**SERVICE INFORMATION**

Bulletin Nbr: 232-1734 UTG. 2

**O-rings may cause problems with driveability****Cars affected**

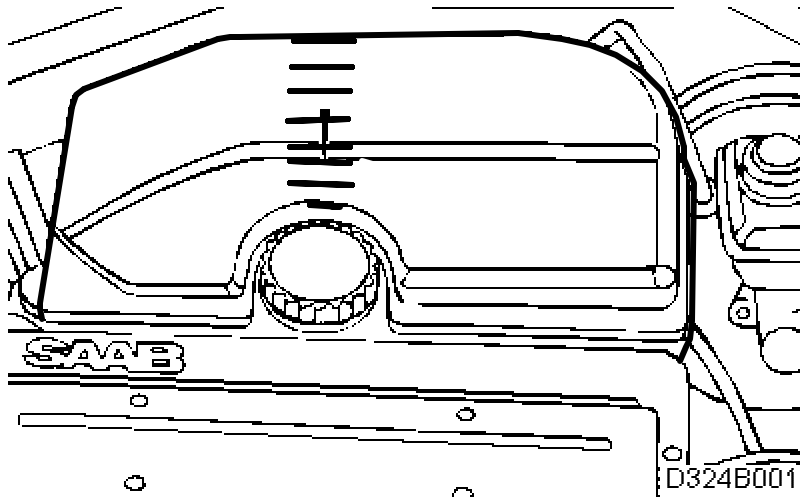
It is possible for the O-rings between the resonator and the throttle body to be fitted incorrectly on assembly causing the engine to take in air that has not passed through the mass air flow sensor. This can result in driveability problems and subsequent fault diagnosis procedures.

The following measures must be taken unconditionally when carrying out work that involves removing the resonator from the throttle body:

- Check O-rings and their locations. Replace deformed O-rings.
- Lubricate O-rings with acid-free vaseline.
